Attachment 3

DISTRICT REGULATIONS AND DESIGN GUIDELINES

District 1 Requirements Gateway Mixed Use Commercial District Adopted

District 1 Requirements Gateway Mixed Use Commercial District Proposed

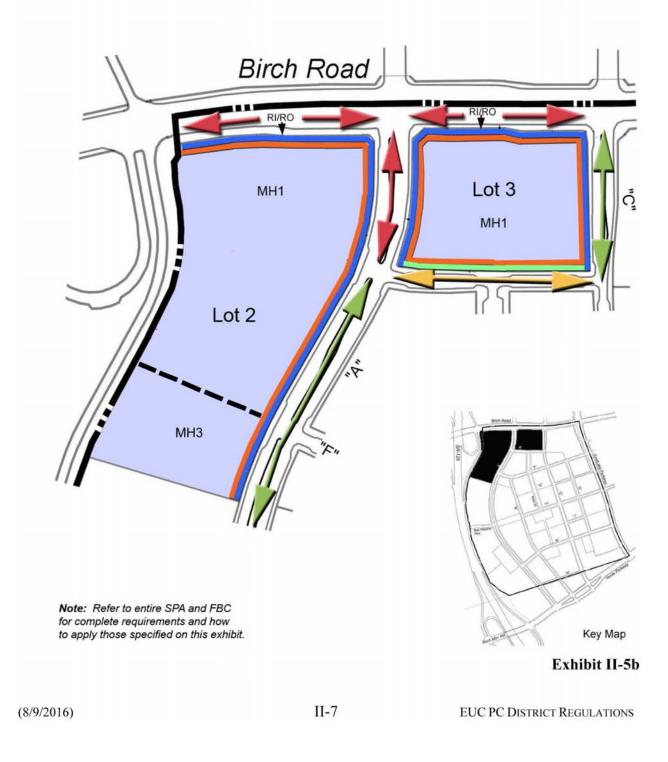
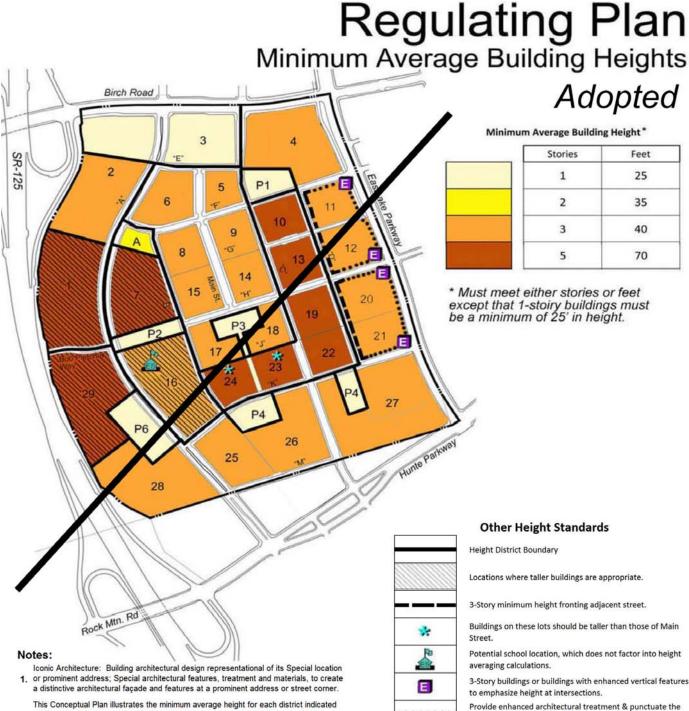
- at full build-out. It does not establish the minimum or maximum heights. Individual buildings may deviate from the minimum average height so long as the overall average within the district is maintained.
- The average heights include parking within the building, but excludes separate parking 3. structures or accessory structures. Refer to the text in this chapter for additional explanation and methods of calculating height.
- 4. Refer also to Chapter 02 for the minimum and maximum building height standards for each street frontage.
- 5. Refer also to exceptions in Chapter 03.09.002b vi, herein.

Regulating Plan Minimum Average Building Heights Proposed

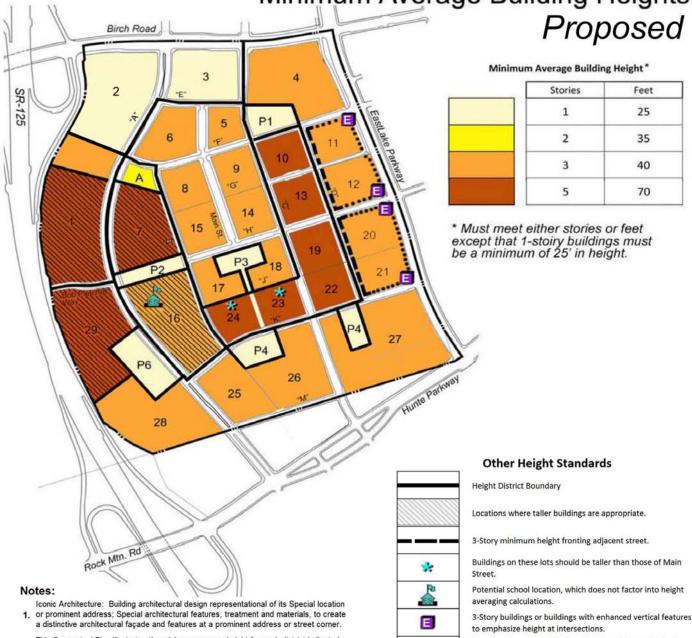
This Conceptual Plan illustrates the minimum average height for each district indicated 2. at full build-out. It does not establish the minimum or maximum heights. Individual buildings may deviate from the minimum average height so long as the overall average within the district is maintained.

The average heights include parking within the building, but excludes separate parking 3. structures or accessory structures. Refer to the text in this chapter for additional explanation and methods of calculating height.

- Refer also to Chapter 02 for the minimum and maximum building height standards for 4. each street frontage.
- 5. Refer also to exceptions in Chapter 03.09.002b vi, herein.

Provide enhanced architectural treatment & punctuate the top building line with vertical elements to avoid a continuous 2-story roof line. (Refer also to Chapter 03.09.02b vi)
